**PROPOSAL FOR DRAFT AMENDMENTS TO REGULATION No. 11**

(Door latches and door retention components)

Transmitted by the expert from the European Commission (EC)

Note: The text presented was transmitted by the expert from the European Commission in order to align the text of Regulation 11 with that of Global Technical Regulation No.1 on the same subject.

Figure 3-1 – Door Latch - Tensile Testing Fixture for Load Test One

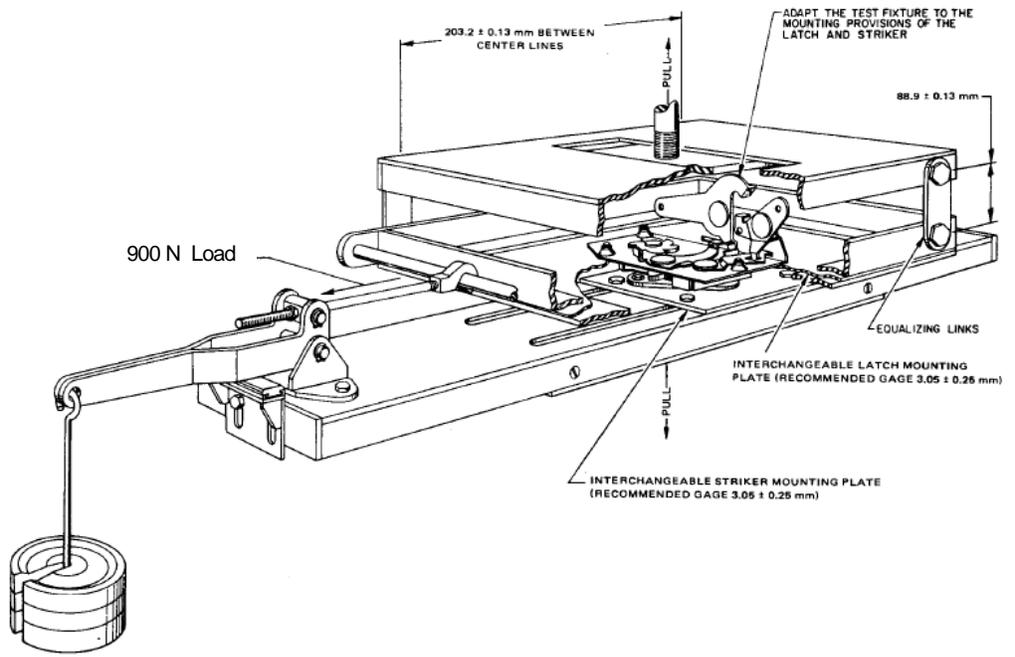
2.1.1. Equipment: Tensile testing fixture (see Figure 3-1).

2.1.2.1.1. Adapt the test fixture to the mounting provisions of the latch and striker. Align the direction of engagement parallel to the linkage of the fixture. Mount the latch and striker in the fully latched position to the test fixture.

2.1.2.1.2. Locate weights to apply a 900 N load tending to separate the latch and striker in the direction of the door opening.

2.1.2.1.3. Apply the test load, in the direction specified in paragraph 6.1.1. of this regulation and Figure 3-4, at a rate not to exceed 5 mm/min until the required load has been achieved. Record the maximum load achieved.

Figure 3-2 – Door Latch – Tensile Testing Fixture for Load Test Two

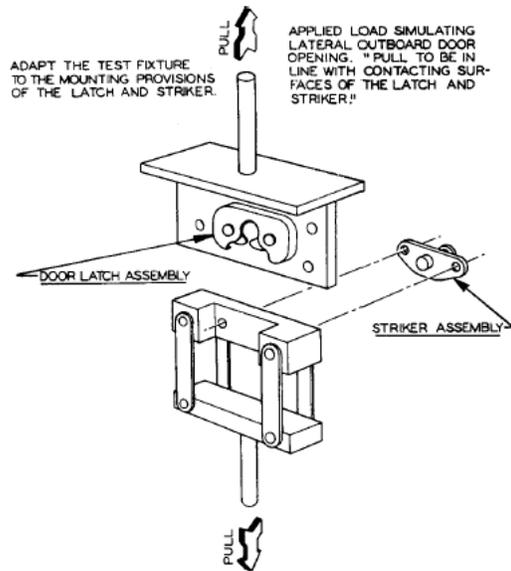
- 2.2. Load Test Two
  - 2.2.1. Equipment: Tensile testing fixture (see Figure 3-2).
  - 2.2.2. Procedures
    - 2.2.2.1. Fully Latched Position
      - 2.2.2.1.1. Adapt the test fixture to the mounting provisions of the latch and striker. Mount the latch and striker in the fully latched position to the test fixture.

- 2.2.2.1.2. Apply the test load, in the direction specified in paragraph 6.1.2. of this regulation and Figure 3-4, at a rate not to exceed 5 mm/min until the required load has been achieved. Record the maximum load achieved.

Figure 3-3 - Door Latch – Tensile Testing Fixture for Load Test Three (Back Doors Only)

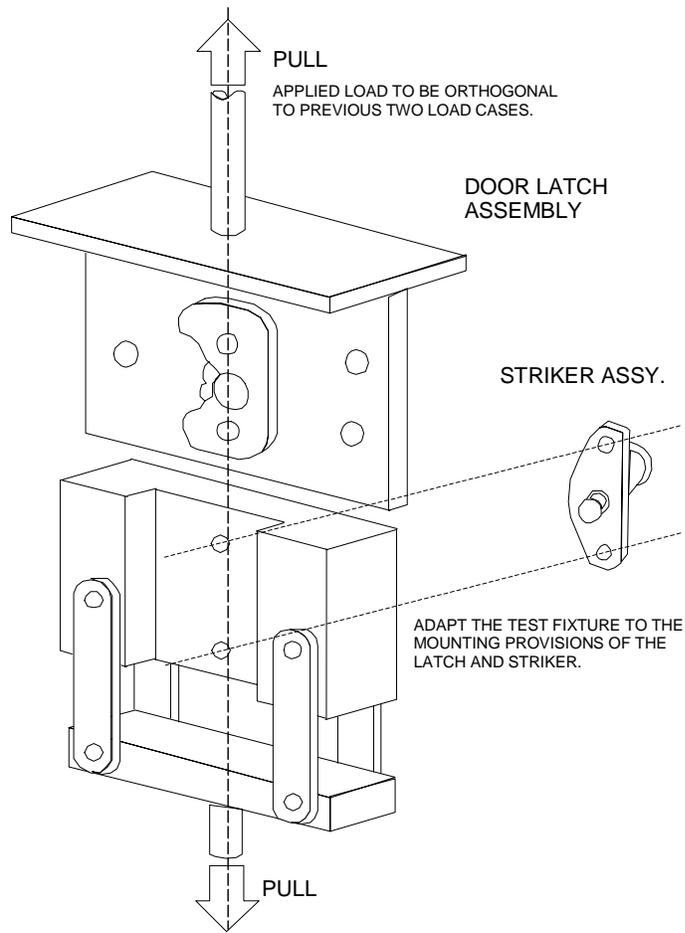
- 2.3. Load Test Three (Back Doors Only)
  - 2.3.1. Equipment: Tensile testing fixture (see Figure 3-3).
  - 2.3.2. Procedure
    - 2.3.2.1. Adapt the test fixture to the mounting provisions of the latch and striker. Mount the latch and striker in the fully latched position to the test fixture.

- 2.3.2.2. Apply the test load, in the direction specified in paragraph 6.1.3. of this regulation and Figure 3-4, at a rate not to exceed 5 mm/min until the required load has been achieved. Record the maximum load achieved.

Figure 3-4 – Door Static Load Test Directions"

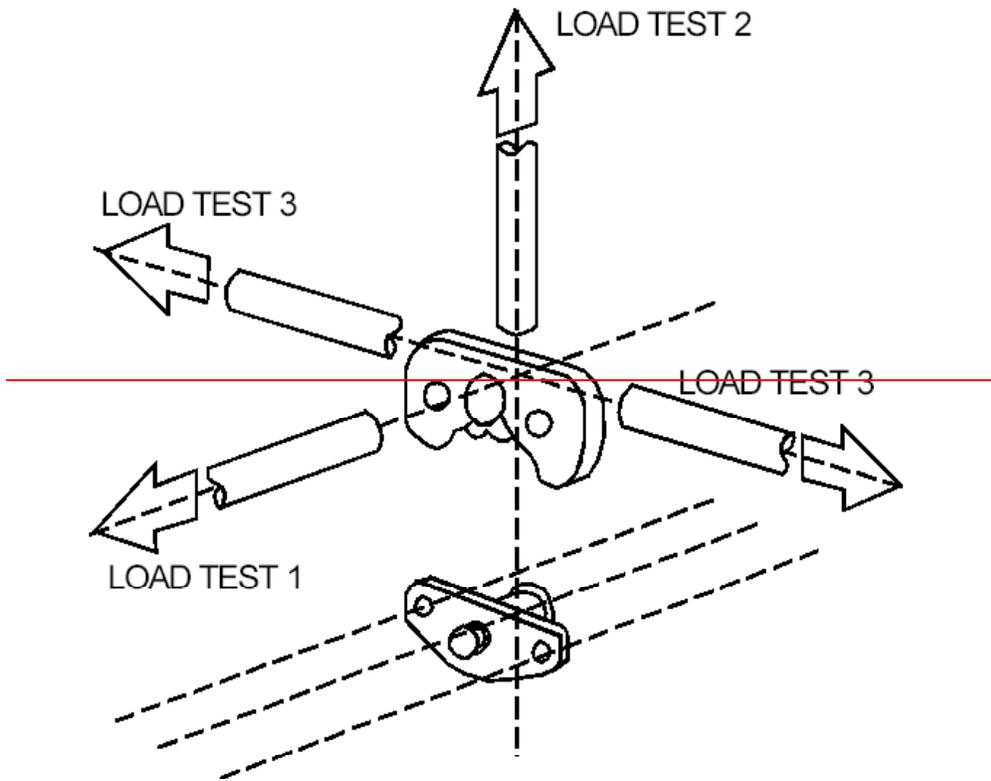
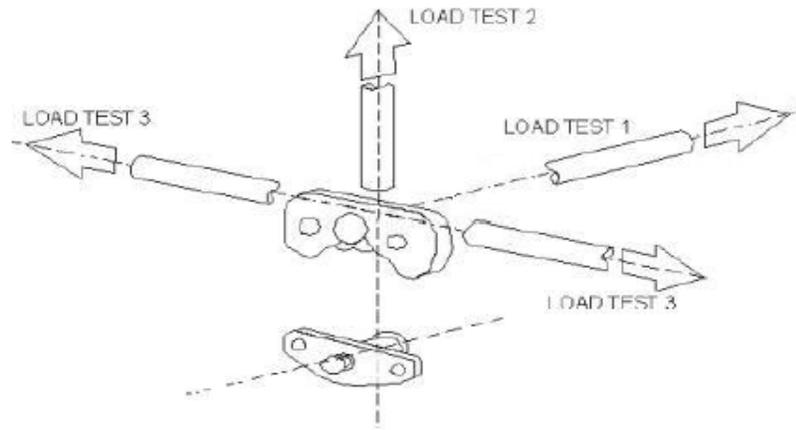
2.1.2.2.3. Apply the test load, in the direction specified in paragraph 6.1.1. of this regulation and Figure 3-4, at a rate not to exceed 5 mm/min until the required load has been achieved. Record the maximum load achieved.

- 2.2.2.2.2. Apply the test load, in the direction specified in paragraph 6.1.2. of this regulation and Figure 3-4, at a rate not to exceed 5 mm/min until the required load has been achieved. Record the maximum load achieved.

**Figure 4-1 – Inertial Loading - Sample Calculation**

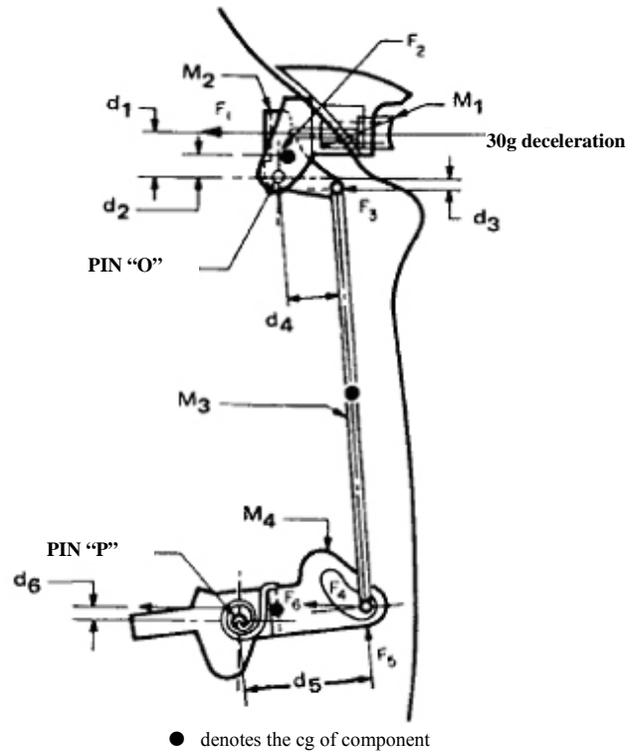
2.1.2. Calculation Consideration - Each component or subassembly can be calculated for its minimum inertial load resistance in a particular direction. Their combined resistance to the unlatching operation must assure that the door latch system (when properly assembled in the vehicle door) will remain latched when subjected to an inertial load of 30 g in any direction. Figure 4-1 is an example of the components and combinations of components to be considered.

Given:  
 Door latch system subjected to a 30g deceleration  
 Average Push-Button Spring Output Force = 0.459kgf  
 Pawl Spring Output Torque = 0.0459kgf m  
 $a = 30g \text{ (m/s}^2\text{)}$   
 $F = ma = m \cdot 30g = m \cdot 294.2$

$M_1 = 0.0163\text{kg}$	$d_1 = 31.50\text{mm}$
$M_2 = 0.0227\text{kg}$	$d_2 = 10.67\text{mm}$
$M_3 = 0.0122\text{kg}$	$d_3 = 4.83\text{mm}$
$M_4 = 0.0422\text{kg}$	$d_4 = 31.50\text{mm}$
	$d_5 = 37.59\text{mm}$
	$d_6 = 1.90\text{mm}$

$$F_1 = M_1 \times a - \text{Average load on knob spring} = (0.0163\text{kg} \times 30g) - 0.459\text{kgf} = 0.03\text{kgf}$$

$$F_2 = M_2 \times a = 0.0227\text{kg} \times 30g = 0.681\text{kgf}$$

$$F_3 = M_3/2 \times a = 0.0122\text{kg}/2 \times 30g = 0.183\text{kgf}$$

$$\begin{aligned} \Sigma M_o &= F_1 \times d_1 + F_2 \times d_2 - F_3 \times d_3 \\ &= 0.03 \times 31.5 + 0.681 \times 10.67 - 0.183 \times 4.83 \\ &= 7.33\text{kgf mm} \end{aligned}$$

$$F_5 = M_o/d_4 = 7.33/31.5 = 0.2328\text{kgf}$$

$$F_6 = M_4 \times a = 0.0422\text{kg} \times 30g = 1.266\text{kgf}$$

$$\begin{aligned} \Sigma M_o &= \text{Pawl spring output torque} - (F_5 d_5 + F_6 d_6)/1000 \\ &= 0.0459 - (0.2328 \times 37.59 + 1.266 \times 1.9)/1000 \\ &= 0.0347\text{kgf m} \end{aligned}$$

Figure 4-2 – Acceleration Pulse

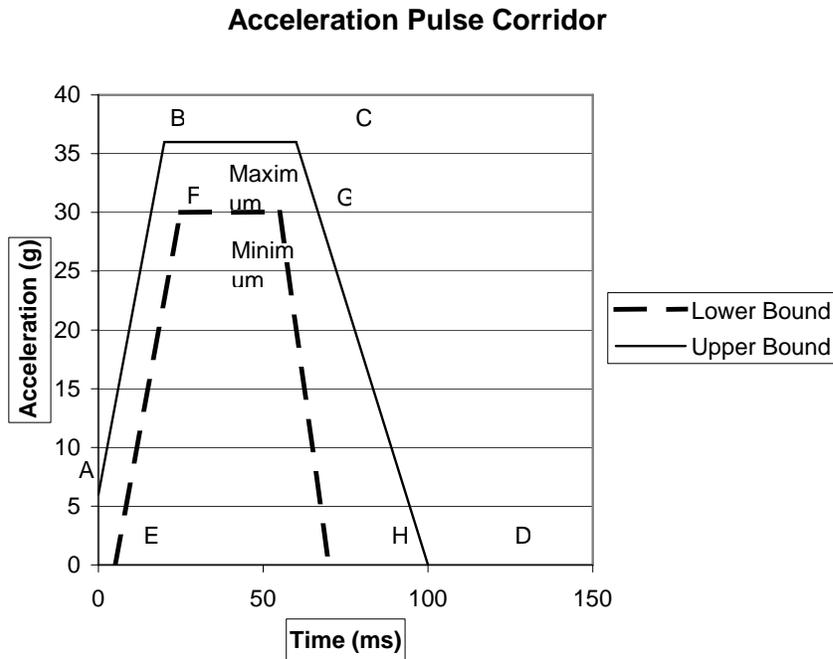
- 2.2.2.1. Rigidly secure the full vehicle or vehicle body in white to a device that when accelerated together will assure that all points on the crash pulse curve are within the corridor defined in Table 4-1 and Figure 4-2.

- 2.4. Test Operation for Options 2 and 3
  - 2.4.1. A minimum acceleration level of 30g shall be maintained over a period of at least 30 ms, while keeping the acceleration within the pulse corridor as defined in Table 4-1 and graphically shown in Figure 4-2.

Upper Bound			Lower Bound		
Point	Time (ms)	Acceleration (g)	Point	Time (ms)	Acceleration (g)
A	0	6	E	5	0
B	20	36	F	25	30
C	60	36	G	55	30
D	100	0	H	70	0

Figure 4-3 - Vehicle Coordinate Reference System for Inertial Testing

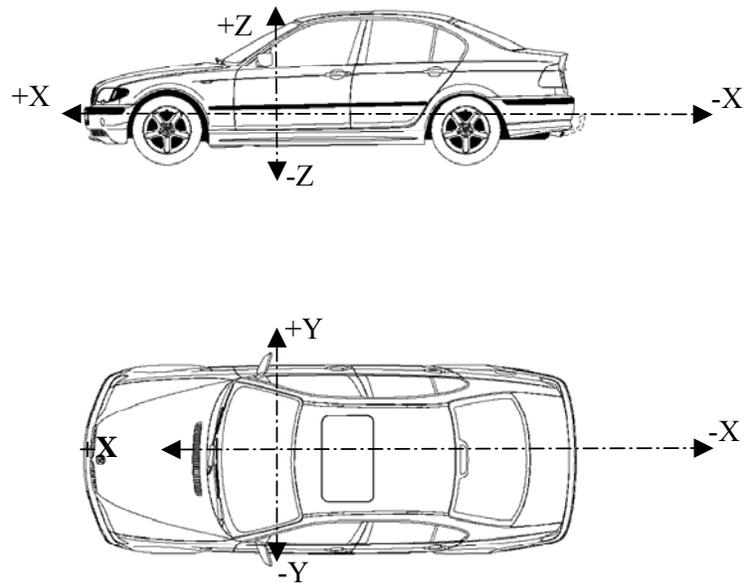
- 2.2.3. Test Directions (see Figure 4-3)
  - 2.2.3.1. Longitudinal Setup 1. Orient the vehicle or body in white so that its longitudinal axis is aligned with the axis of the acceleration device, simulating a frontal impact.

- 2.3.3. Test Directions (see Figure 4-3)
  - 2.3.3.1. Longitudinal Setup 1. Orient the door subsystem(s) on the acceleration device in the direction of a frontal impact.

Figure 5-1 – Static test fixtures

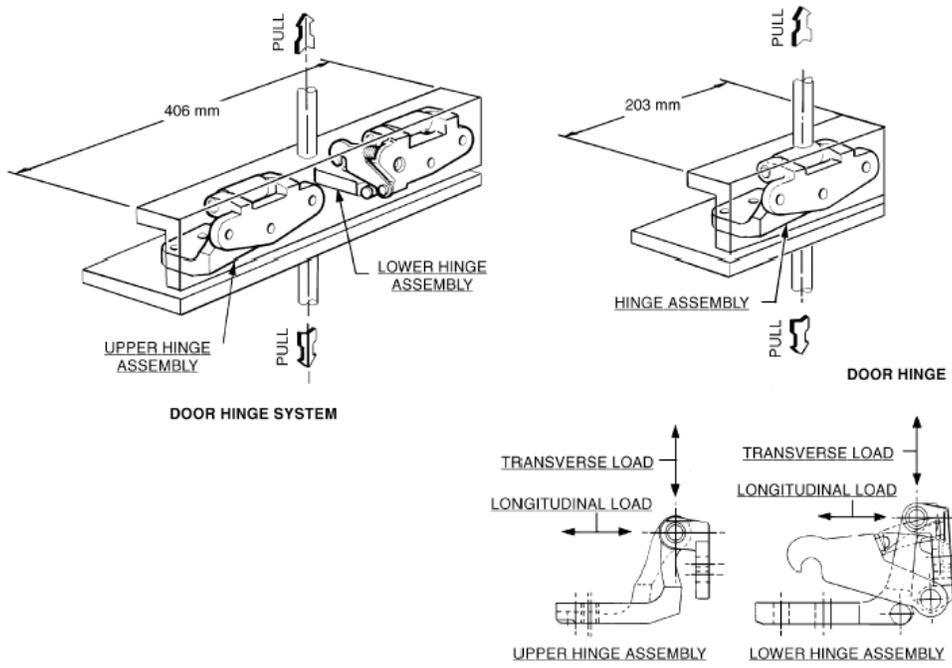
2.1.1.1.2. A typical static test fixture is illustrated in Figure 5-1.

2.1.2.1.2. A typical static test fixture is illustrated in Figure 5-1.

- 2.1.3.1.2. A typical static test fixture is illustrated in Figure 5-1.

Figure 5-2 – Static load test directions for back doors

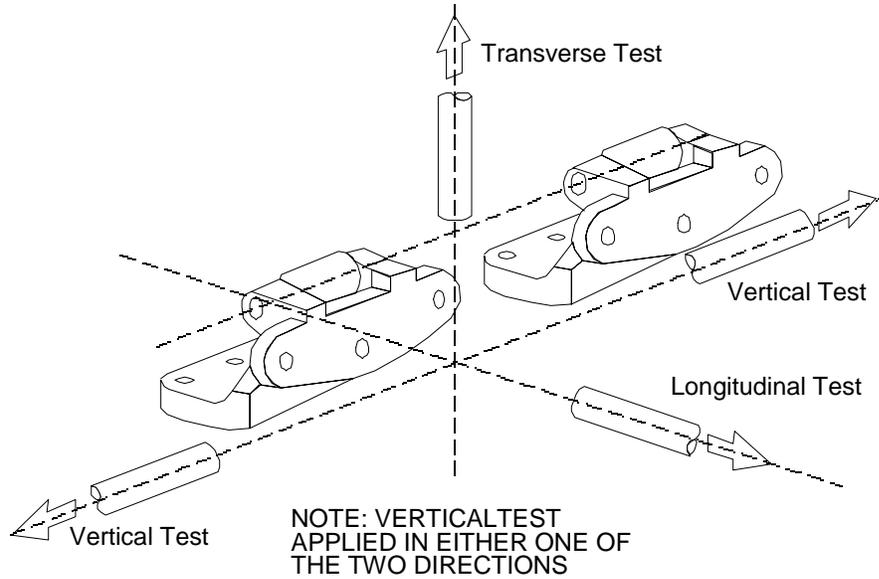
2.1.1.2.1. Attach the hinge system to the mounting provision of the test fixture. Hinge attitude must simulate vehicle position (door fully closed) relative to the hinge centreline. For test purposes, the distance between the extreme ends of one hinge in the system to the extreme end of another hinge in the system is to be set at  $406 \pm 4$  mm. The load is to be applied equidistant between the linear centre of the engaged portions of the hinge pin and through the centreline of the hinge pin in the longitudinal vehicle direction. (see Figure 5-2)

**Figure 6-1 – Sliding Side Door Full Vehicle Test Procedure**  
 (Note: Sliding door is shown separated from the vehicle)"

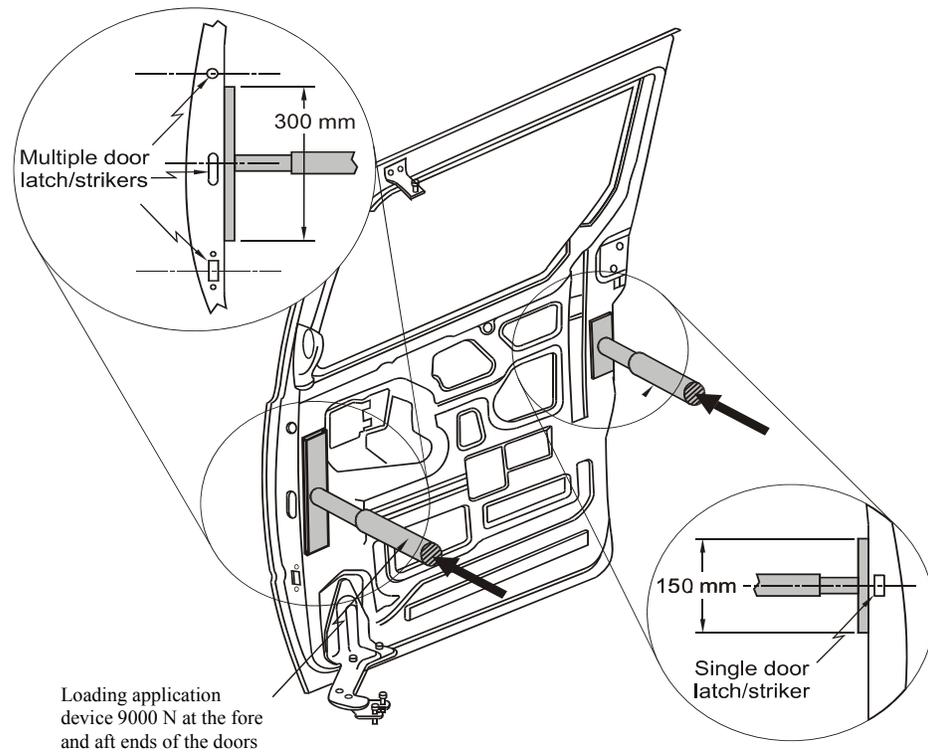
2.2. The test is conducted using two force application devices capable of applying the outward transverse forces specified in paragraph 6.2.4. of this regulation. The test setup is shown in Figure 6-1. The force application system shall include the following:

- 4.2. If one of the force application devices reaches the target force of 9,000 N prior to the other, maintain the 9,000 N force with that force application device until the second force application device reaches the 9,000 N force.
- 4.3. Once both force application devices have achieved 9,000 N each, stop forward movement of the force application devices and hold under the resulting load for a minimum of 10 seconds.
- 4.4. Maintain the force application device position of paragraph 4.3. and measure the separation between the exterior edge of the doorframe and the interior of the door along the perimeter of the door.
